TOWN OF NORWICH  
DEVELOPMENT REVIEW BOARD  
AGENDA  
Thursday, September 3, 2020  
7:00 PM

1. Call to Order, Roll Call
2. Approve Agenda
3. Public Comments & Announcements
4. Continuation of Public Hearing:
  - a. #29BCU20 Conditional Use and Site Plan Review for a Daycare and a Cultural Facility (school) with apartment. Tiny Seeds Village, LLC. applicant and landowner of Lot 11-093.000 at 251 US Route 5N. Application to be reviewed under the Norwich Zoning Regulations.

Town of Norwich  
Development Review Board

**SUBJECT:** Tiny Seeds Norwich Traffic Support

**FIGURE 6: INTERSECTION SIGHT DISTANCE FROM NORTHBOUND LEFT-TURN**

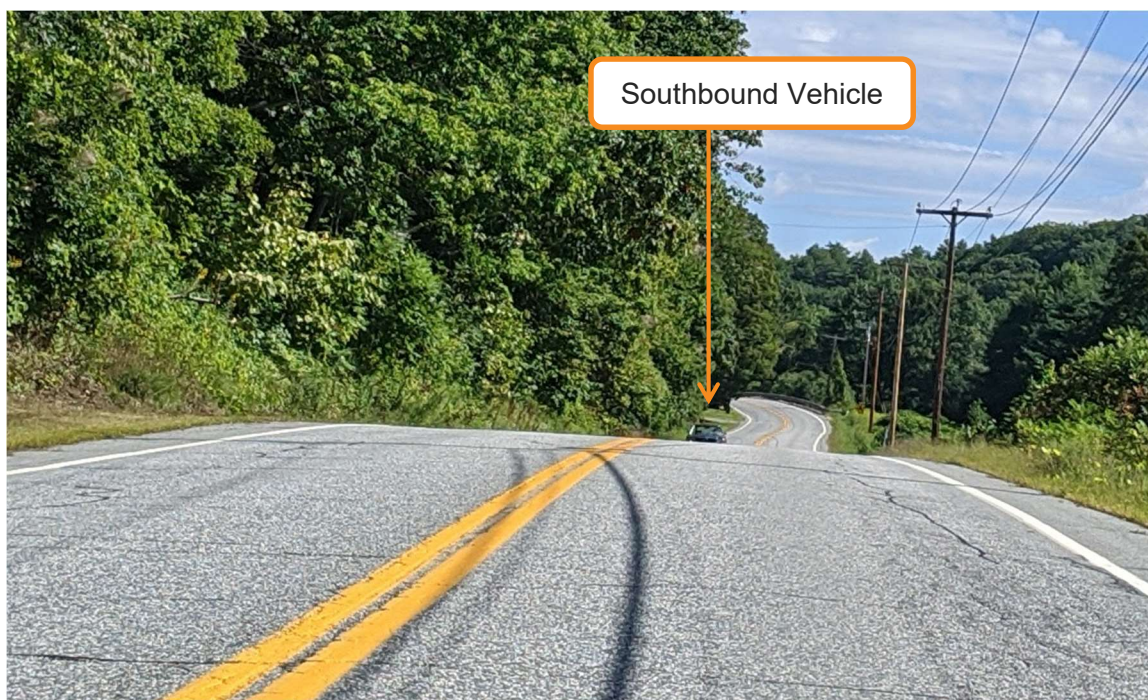
Additionally, intersection sight distance was measured for the northbound left-turn movement. Based on the 50 MPH posted speed limit the design minimum intersection sight distance for this movement is 405 feet. The intersection sight distance for this movement is greater than 1,000 feet. From the turning location, the sight line between driver's eyes is maintained throughout the crest vertical curve.

Figure 6 was taken from the height of a left-turning driver's eye looking north. The oncoming vehicle maintains visibility throughout the crest vertical curve.
